Town of Kittery Maine Planning Board Meeting October 24, 2019

ITEM 1 – 60 Route 236 – Final Site Plan Review

Action: Approve with or without conditions, continue consideration of or deny plan Owner/applicant Washburn Realty Group, LLC requests consideration of a preliminary site plan for a 4,603 sf 2-story building on a 73,330 sf lot at 60 Route 236 (Tax Map 29, Lot 14) in the Commercial (C-2) Zone. Agent is John Chagnon, Ambit Engineering, Inc.

SITE LAYOUT PLAN
C3

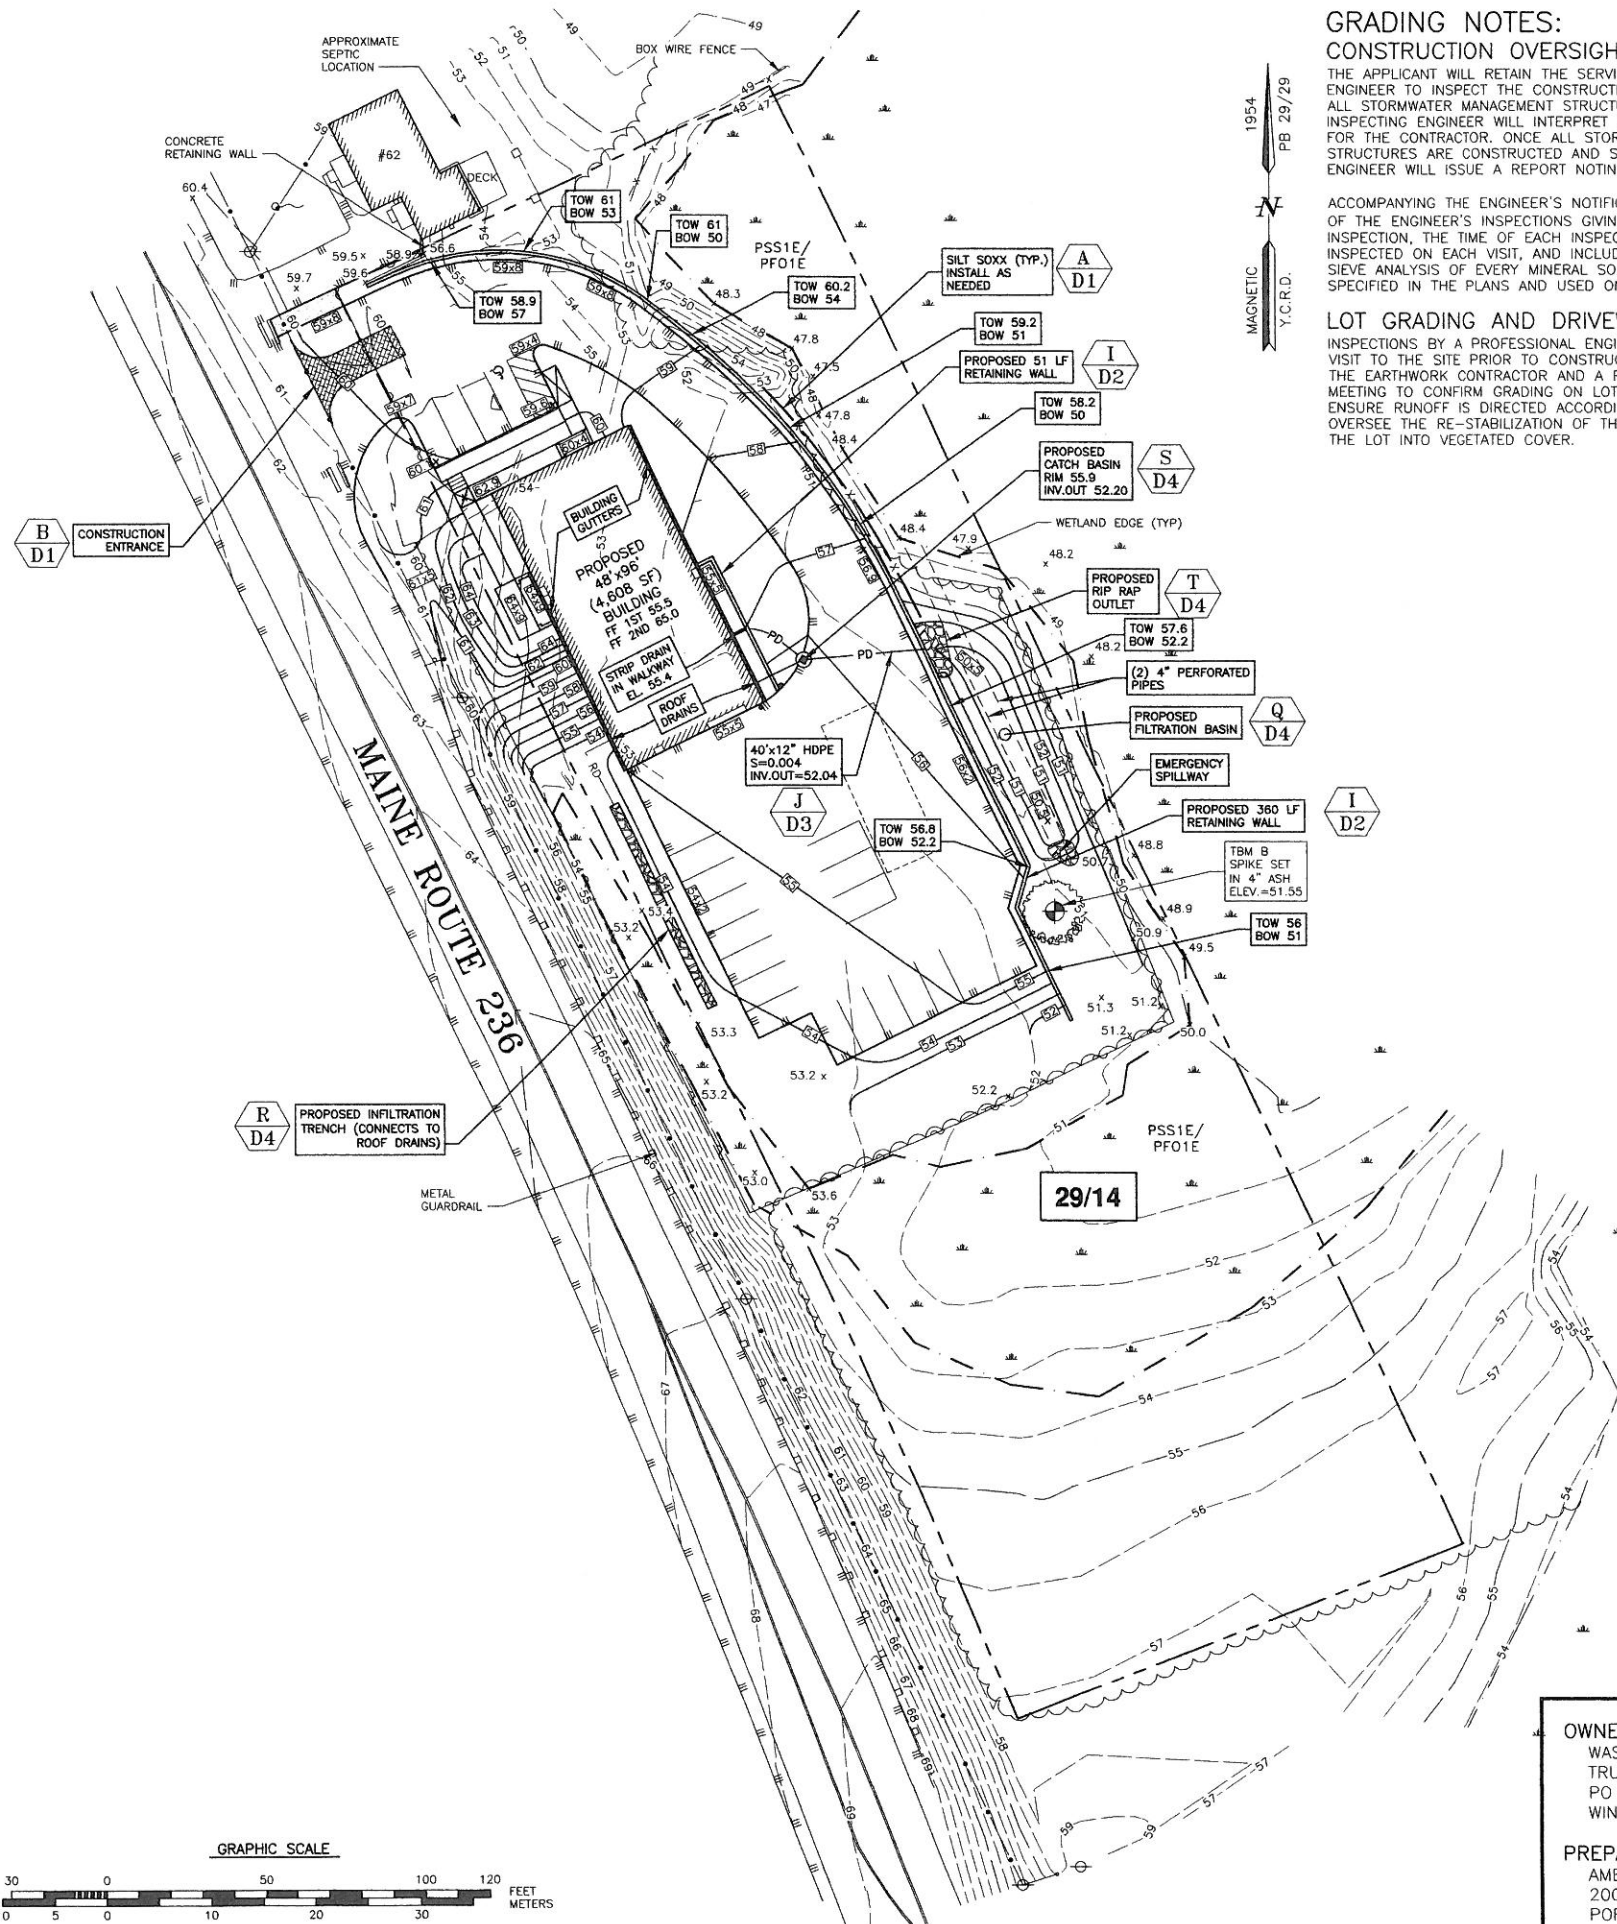
- 1) Revise the Site Layout plan and Landscape Schedule to accommodate more landscape plantings for aesthetics and to effectively buffer the parking lot; and,
- 2) Provide a lighting and photometric plan.

The applicant has submitted a final plan which addresses those conditions.
